Memorandum to the City of Markham Committee of Adjustment

File: A/019/22
Address: 7089 Yonge Street – Markham, ON (Thornhill)
Applicant: Devron Developments (Adrienne Van)
Hearing Date: May 4, 2022

The following comments are provided on behalf of the West District team. The applicant is requesting relief from the following requirements of Parking Standards By-law 28-97, as amended (the “Parking By-law”), as they relate to legalizing reduced parking space sizes. The requested variances are to permit:

Site Plan, Context Plan and Statistics

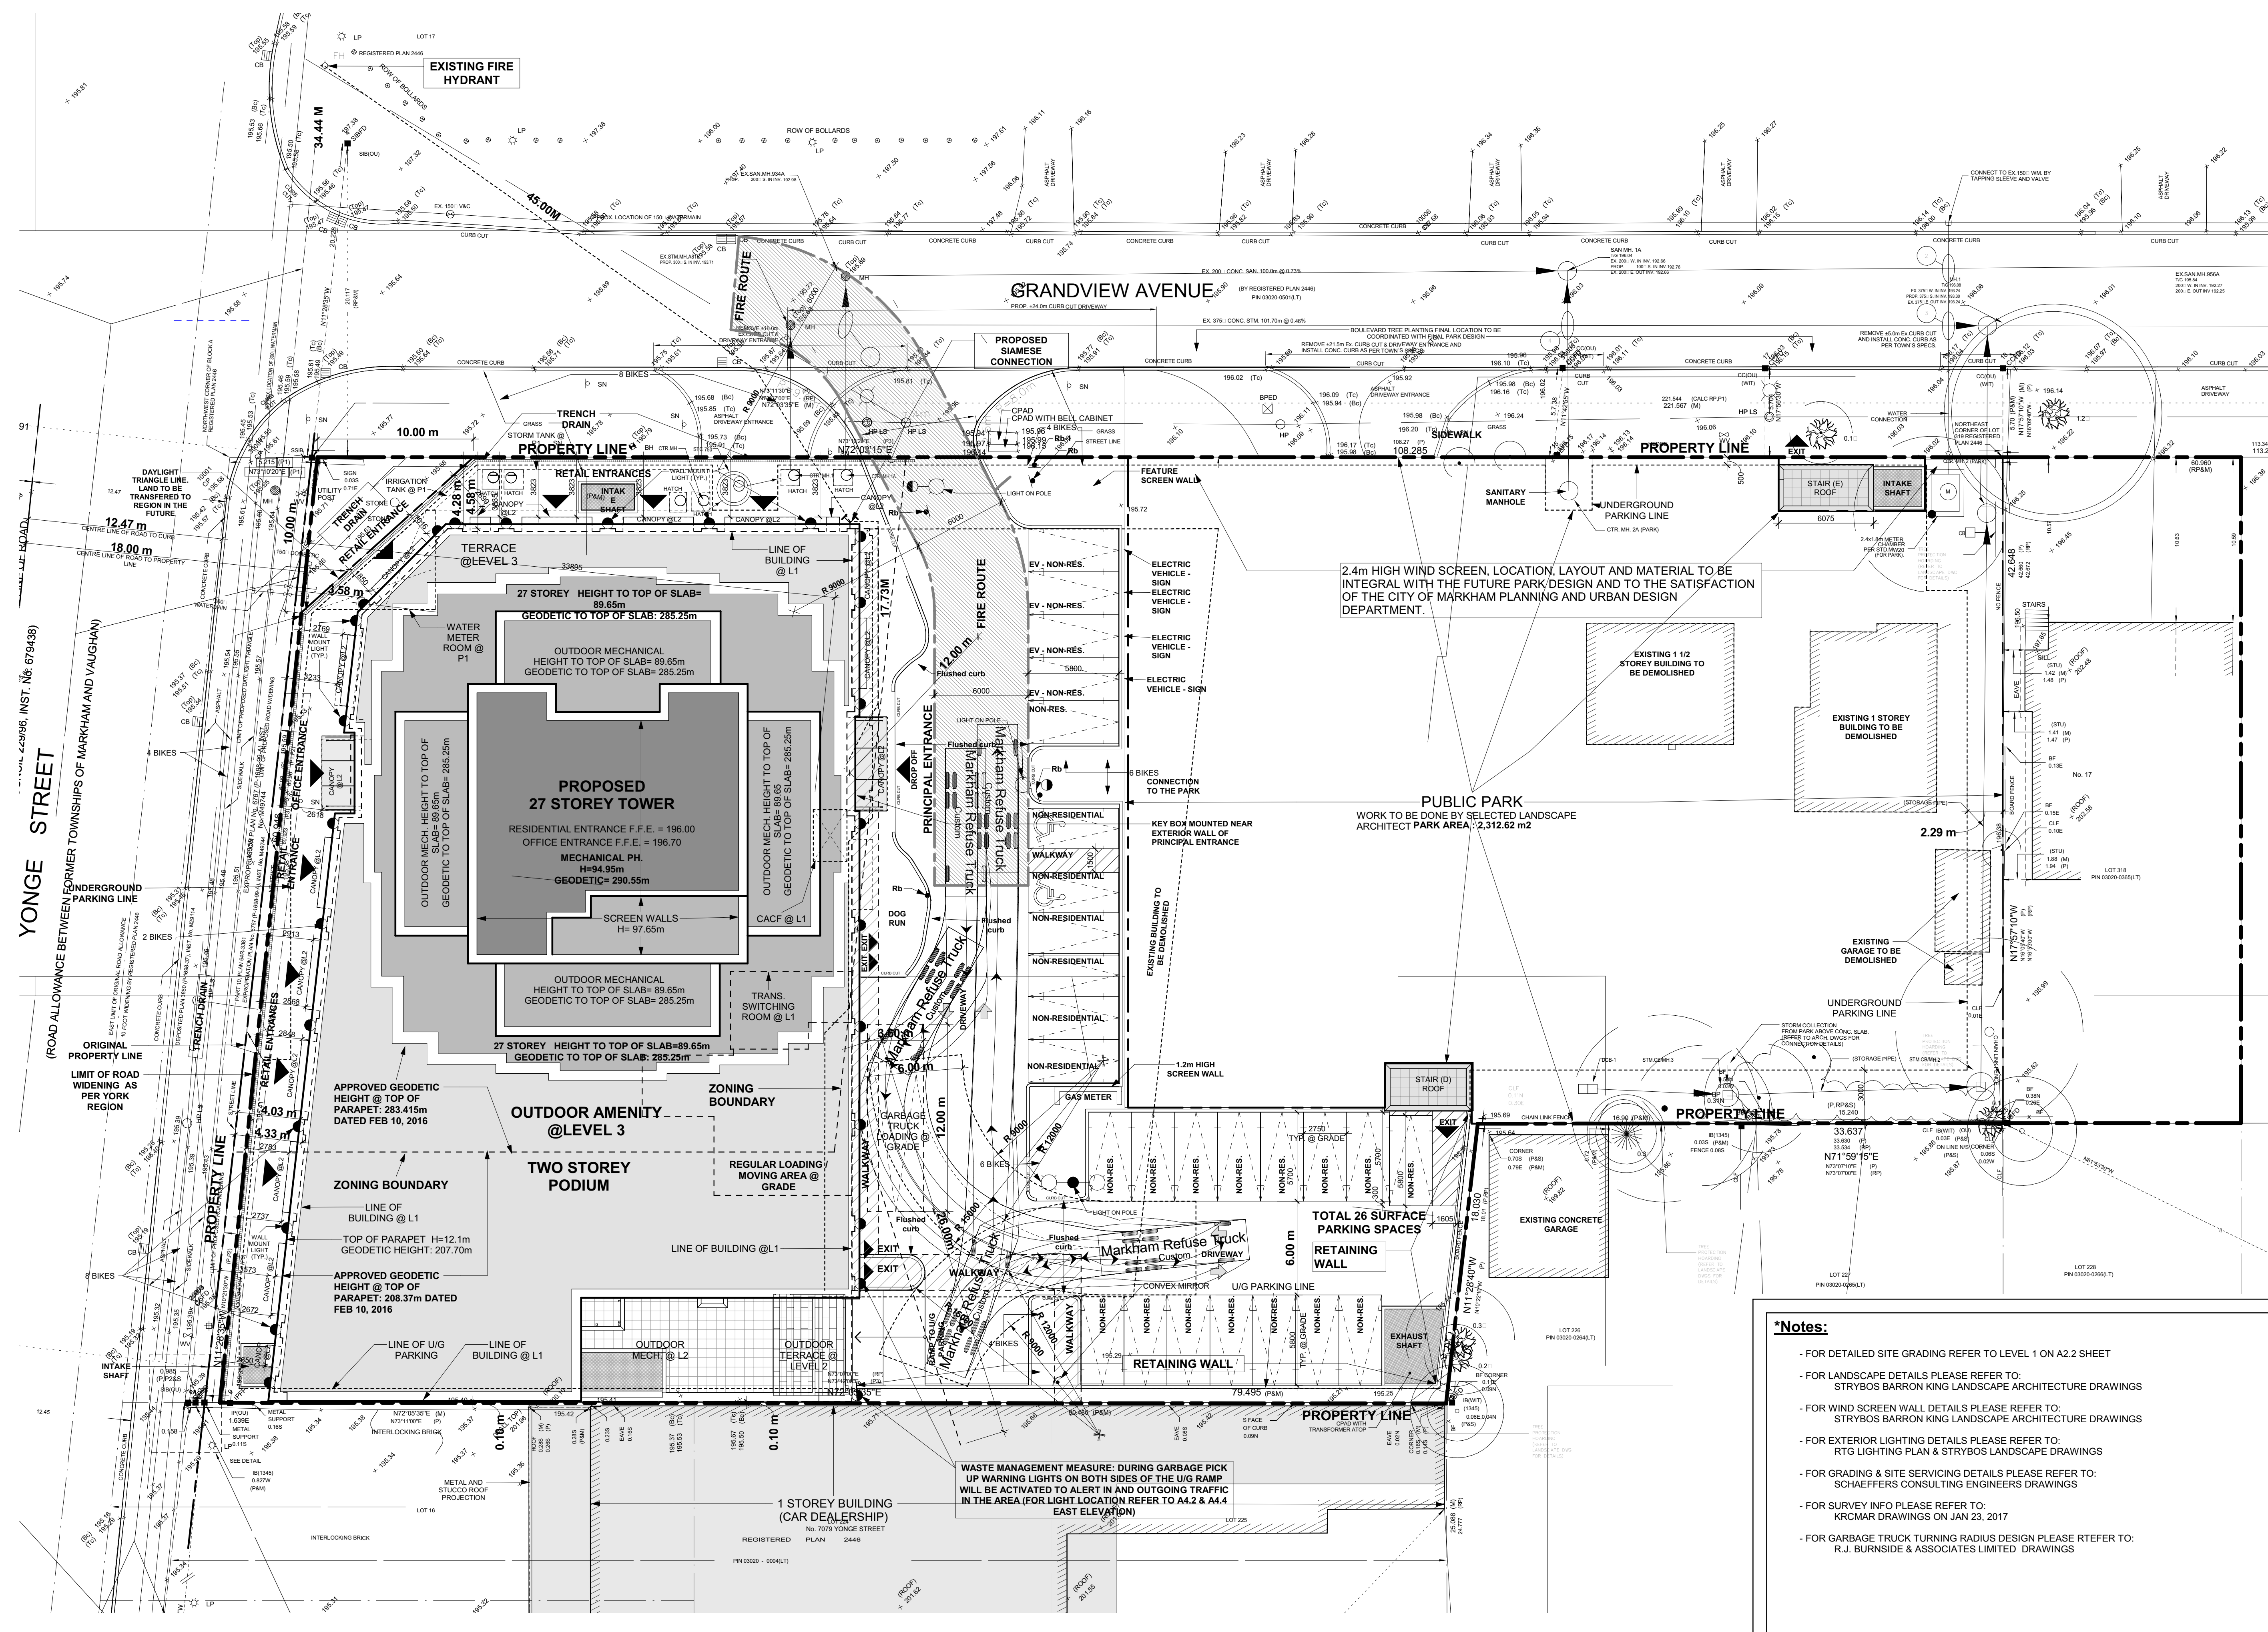
Located at the southeast corner of the property are 15 surface non-residential parking spaces, eight of which are located on the north side of the two-way drive aisle. Seven of the eight parking spaces have been constructed with a parking length that does not comply with the Parking By-law size requirements (see parking spaces #19 - #25 in Appendix "C"). The applicant requests variances to legalize the length of the parking spaces as noted above: six would have a length of 5.70 m (18.70 ft) (parking spaces #19 - #24) and one would have a length of 5.40 m (17.72 ft) (parking space #25), whereas the By-law requires that each parking space has a length of no less than 5.80 m (19.03 ft). This is a reduction of 0.10 m (0.33 ft), and 0.40 m (1.31 ft), respectively.

The applicant submitted a transportation letter and maneuvering analysis drawing, which concludes that the proposed parking sizes can accommodate the maneuvering of passenger vehicles. Transportation staff have reviewed the letter, and concur with the study's findings within this specific site context. The letter notes that there is currently a bollard that exists within the most easterly parking space (#19), and that the bollard is intended to be relocated while ensuring protection of the gas supply lines. The applicant has noted that the requested reduction to the size of parking space #25 as shown in Appendix "C" "*will legally need to be 5.40 m (17.72 ft) due to the location of the residential condo boundary*".

1. That the variances apply only to the seven surface parking spaces for as long as they remain.
2. That the applicant submits site photos to the Director of Planning and Urban Design or designate, that shows the bollard which is currently located within the existing parking space has been relocated outside of the parking area relating to the subject development, and that the Secretary-Treasurer receive written confirmation that the site photos have been reviewed to the satisfaction of the Director of Planning and Urban Design, or their designate.

3. That the applicant installs signage for each parking space that indicates "*this parking space length is substandard, and is recommended for small vehicles only*", and that the Secretary-Treasurer receive written confirmation that this condition has been fulfilled to the satisfaction of the Director of Planning and Urban Design, or their designate.
